PS North Closed Loop Interface

**PJM FTRSTF Meeting
July 16, 2014**

**Highlands Energy Group
Martin Matijasich**

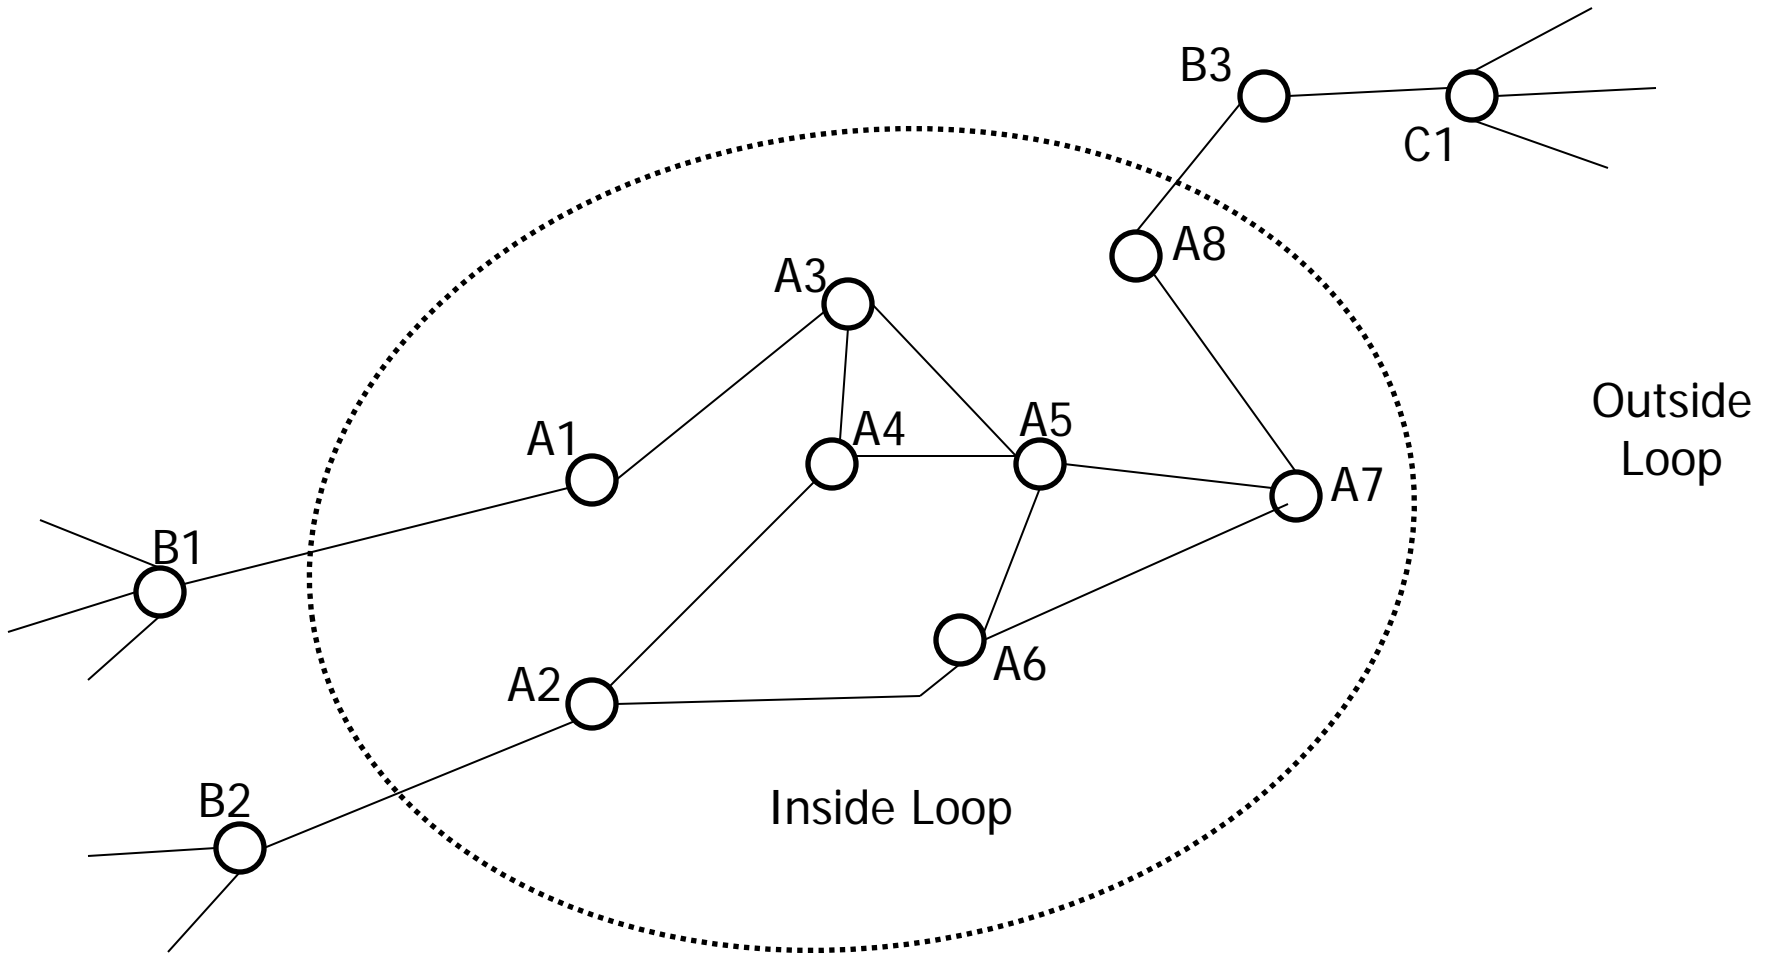
A) Highlands Observations for Closed Loop Binding Constraints:

All PNODES inside the Closed Loop have the same Shadow Price.

B) Discussion Questions:

- 1) How are the Marginal Unit(s) determined for a Closed Loop Interface?
- 2) How are the Shadow Prices calculated for a Closed Loop Interface?
- 3) For a transmission maintenance outage of B3 to C1, will B3 have the same Shadow Price as A8?
- 4) For a transmission maintenance outage of A7 to A8, will A8 have the same Shadow Price as B3?

C) Request to PJM:

Present a tutorial using a hypothetical Closed Loop Interface that addresses the above Discussion Questions.

The tutorial should include a detailed example showing Shadow Price calculations.
